# Nipa Fashion Wear Company Ltd.

Holan Road, Dakkin Khan, Uttara, Dhaka – 1230  
(23.856611N, 90.431042E)

13 July 2014

# Observations

# **Function of Masonry Columns Centred on Construction Joint, not Apparent**

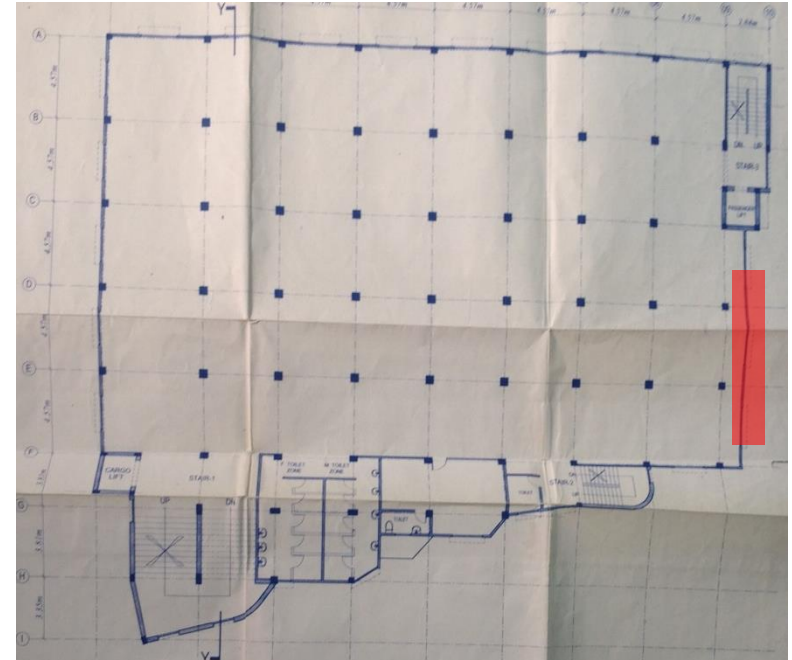
Purpose of masonry columns not apparent.

Masonry Columns constructed at junction of factories

| Item No. | Observation                                                                              | Recommended Action Plan                                                                                                                                                                  | Recommended Timeline |
|----------|------------------------------------------------------------------------------------------|------------------------------------------------------------------------------------------------------------------------------------------------------------------------------------------|----------------------|
| 11       | Function of Masonry Columns at Ground Floor, Centred on Construction Joint, not Apparent | Building Engineer to investigate function and construction method of columns identified above, with particular attention to be paid to location of column in relation to movement joint. | 6-months             |
| 12       | Function of Masonry Columns at Ground Floor, Centred on Construction Joint, not Apparent | Building Engineer to Design and detail Structural Upgrading works as necessary                                                                                                           | 6-months             |

# Uncontrolled Material Storage

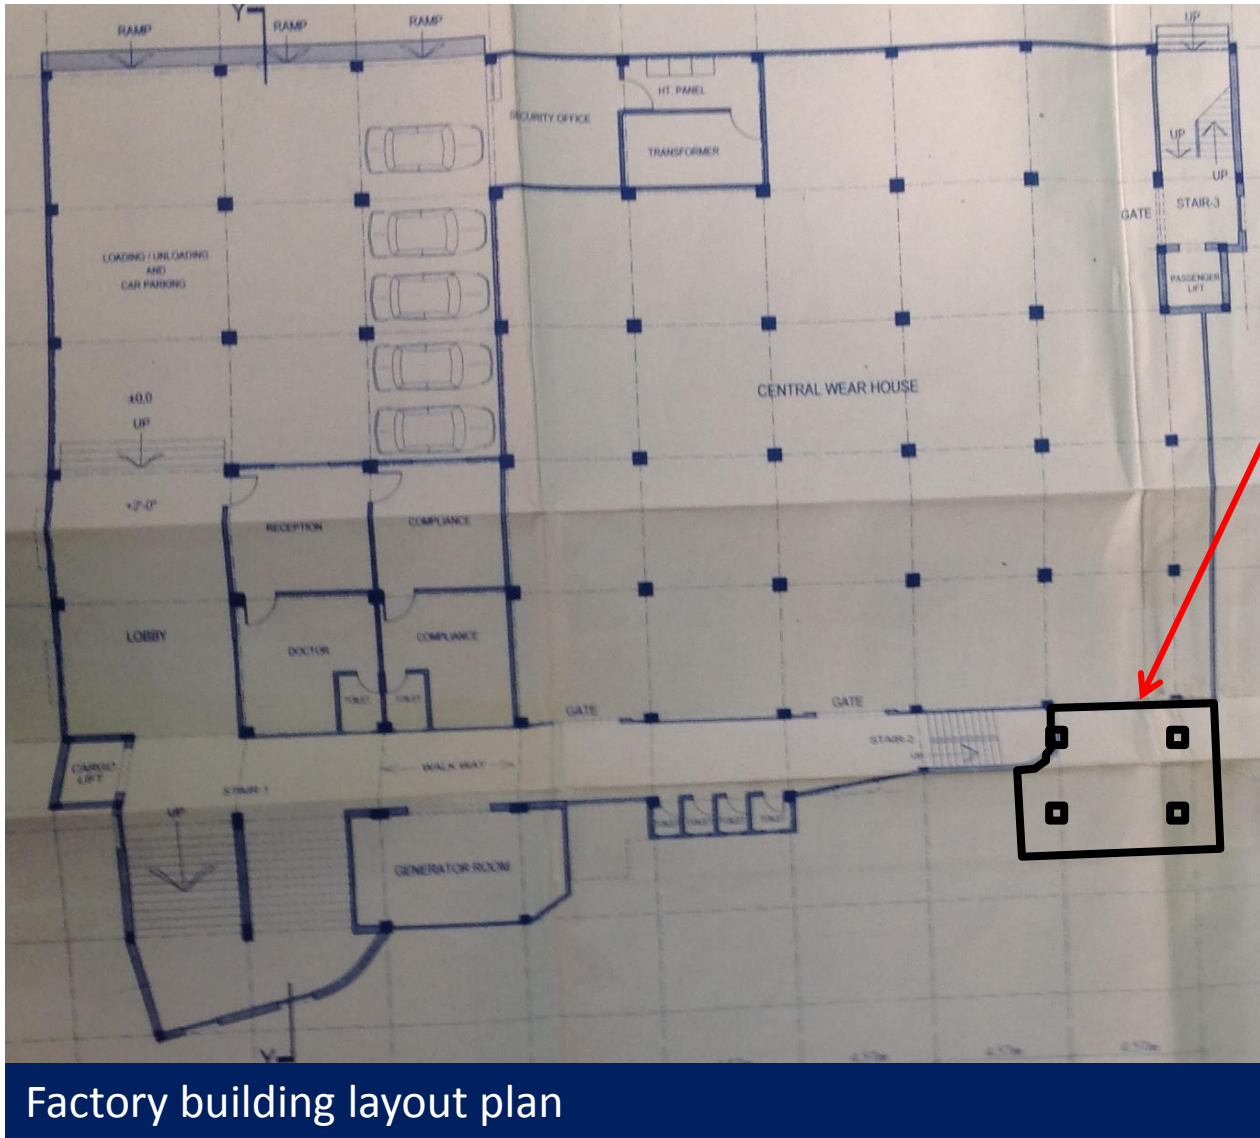
5<sup>th</sup> Floor: Uncontrolled Finished Goods storage

5<sup>th</sup> Floor: Uncontrolled Finished Goods storage

4<sup>th</sup> Floor: Uncontrolled Finished Goods storage

4<sup>th</sup> Floor: Uncontrolled Fabric storage

| Item No. | Observation                                                                     | Recommended Action Plan                                                                                                                                                                                                                 | Recommended Timeline |
|----------|---------------------------------------------------------------------------------|-----------------------------------------------------------------------------------------------------------------------------------------------------------------------------------------------------------------------------------------|----------------------|
| 15       | Implementation of load management plan                                          | Building engineer to clearly display allowable floor loading on all floors of factory building based on loading plans in DEA.                                                                                                           | 6-months             |
| 16       | Implementation of load management plan                                          | Building Engineer to monitor storage on all upper floors and ensure compliance with loading plans.                                                                                                                                      | 6-months             |

Factory building layout plan

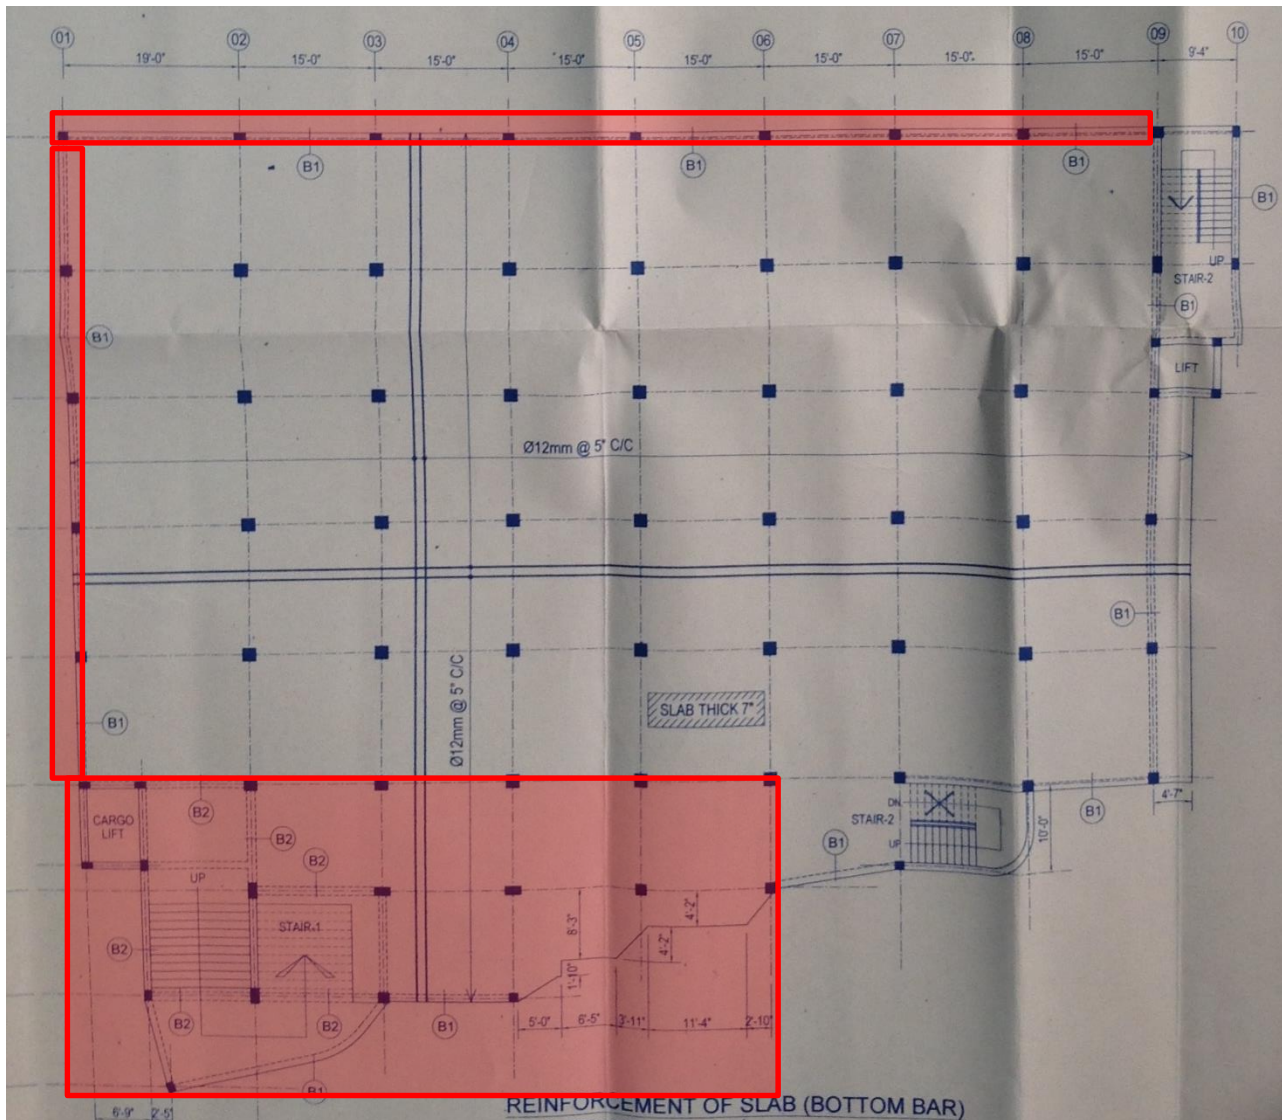
Perimeter beams shown on structural drawings not constructed.

As Built beam layout in Stair Core and Toilet area not consistent with structural drawings

Practical beam layout

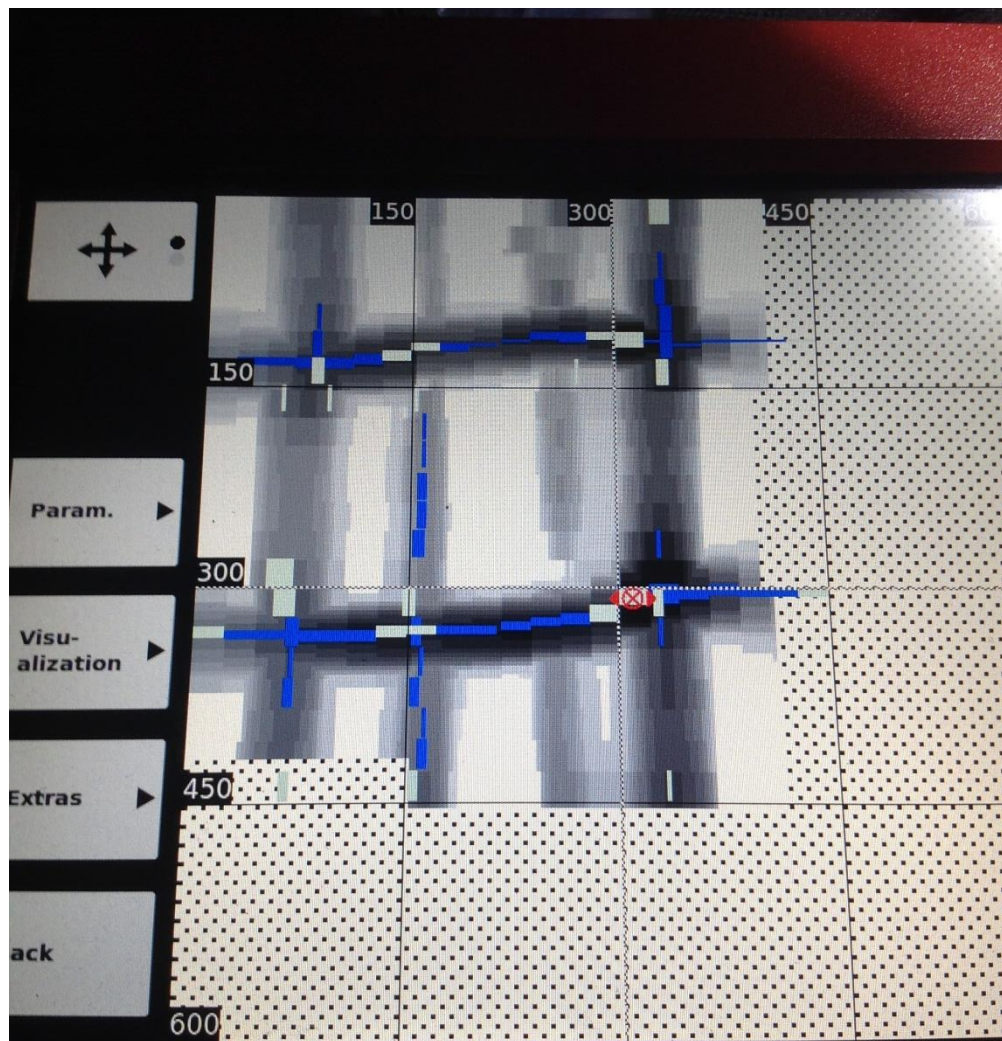
Ferro scan of internal column (C4) confirmed 4 bars in each face.

Column Reinforcement Schedule does not match As Built Construction.

For Column C4 Reinforcement Schedule specifies 16 No. - 25mm diameter bars.
